**LEVY NUCLEAR POWER PLANT, UNITS 1 AND 2
DOCKET NOS. 52-029 AND 52-030
SUPPLEMENT 2 TO RESPONSE TO REQUEST FOR ADDITIONAL INFORMATION LETTER
NO. 035 RELATED TO SURFACE FAULTING**

**Levy Nuclear Power Plant Units 1 and 2
Supplement 2 to Response to NRC Request for Additional Information Letter No. 035
Related to SRP Section 2.5.3 for the Combined License Application,
Dated May 8, 2009**

RAI 02.05.01-39 Figure 2

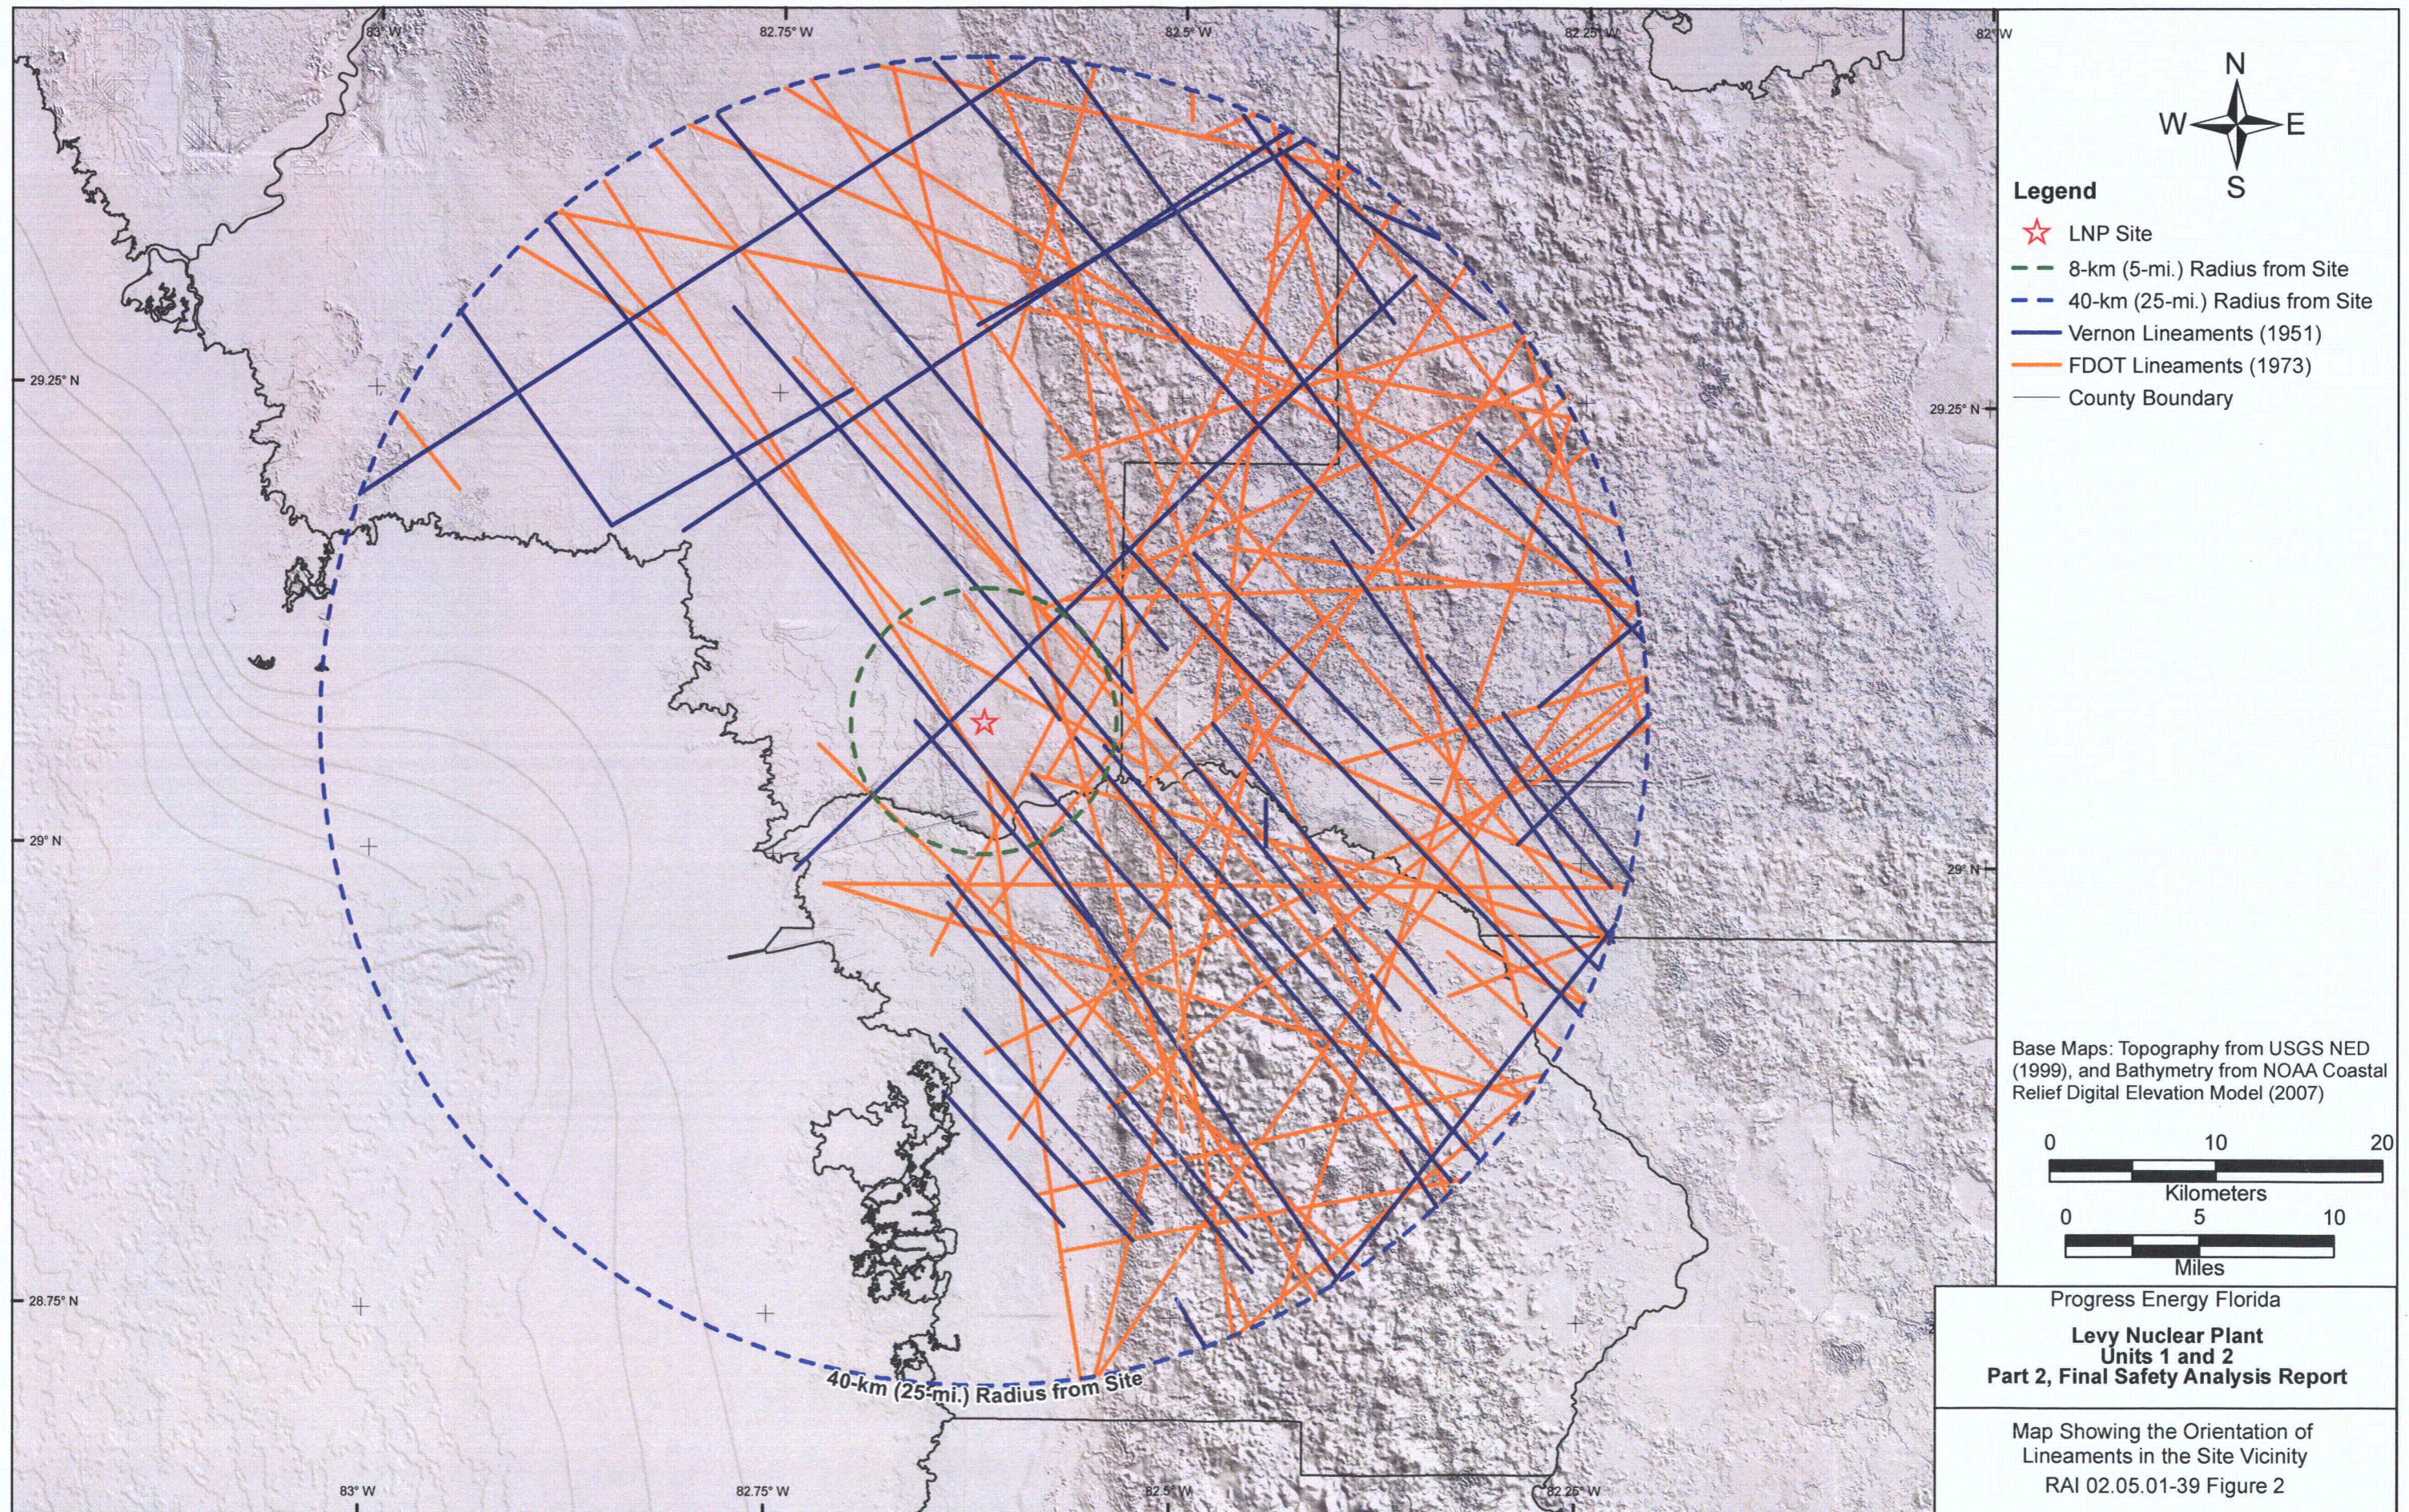
FSAR Section 2.5.3.4 (pg 2.5-182) states that there are no pronounced lineaments trending across the site location that suggest either a through-going fault or a major fracture system. However, maps of the site location (e.g., Figures 2.5.3-216, 2.5.3-218, and 2.5.3-220) appear to illustrate a northwest-trending lineament that, while discontinuous, could define part of a regional fracture system along which possible paleosinkholes occur. FSAR Section 2.5.3.2.1.3 (pg 2.5-182) states that the LNP1 and LNP2 sites are located between zones of prominent northwest-trending lineaments, while a zone of northeast-trending lineaments lies between the two units.

In order for the staff to assess whether regional fracture trends cross-cut the site location, please discuss lineaments illustrated in Figures 2.5.3-216, 2.5.3-218, and 2.5.3-220 in regard to whether they may represent geologic structures.

Diagrams showing the orientation of lineaments identified in the LNP site location (1-km [0.6-mi.] radius) and orientations of fracture sets reported from mapping of the Crystal River Unit No. 3 (CR3) excavation are shown on RAI 02.05.01-39 Figure 3. Comparison of these data sets shows that the orientation of the lineaments observed in the site location are consistent with the mapped bedrock fracture (joint) trends at CR3. The most prominent trends observed in the lineament data also are consistent with observations of fracture sets mapped in exposures of the Avon Park Formation at the Gulf Hammock quarry and Wacasassa River localities (RAI 02.05.01-39 Figures 2 and 3). The prominent northwest-trending alignment of shallow depressions/wetlands identified approximately 300 m (1000 ft.) west of the LNP unit footprints (FSAR Figures 2.5.3-216, 2.5.3-218, and 2.5.3-220) is consistent with the predominant fracture set mapped by Vernon (Reference 2.5.1-262) based on analysis of regional lineaments and with one of the predominant orthogonal fracture sets mapped in exposures of the Avon Park Formation at the Gulf Hammock quarry and Wacasassa River localities (RAI 02.05.01-39 Figures 2 and 3).

These observations support the statement made in FSAR Section 2.5.3.2.1.3 (pp. 2.5-182) that the lineaments mapped in the site location likely reflect structurally controlled joints that have been enhanced by dissolution of carbonate and marine erosion. The predominant trends of fracture sets at the site inferred from the mapped lineaments are consistent with regional trends, and text in FSAR Sections 2.5.3.2.1.3 and 2.5.3.4 will be revised in a future revision to clarify this observation. The discontinuous expression of the lineaments in the site location, the low relief exhibited by the marine terrace surface at the LNP site, and the absence of evidence of surface faulting observed in borings or from interpretation of boring data at the LNP site support conclusions in the FSAR that there is evidence of no capable tectonic surface deformation present at the site.
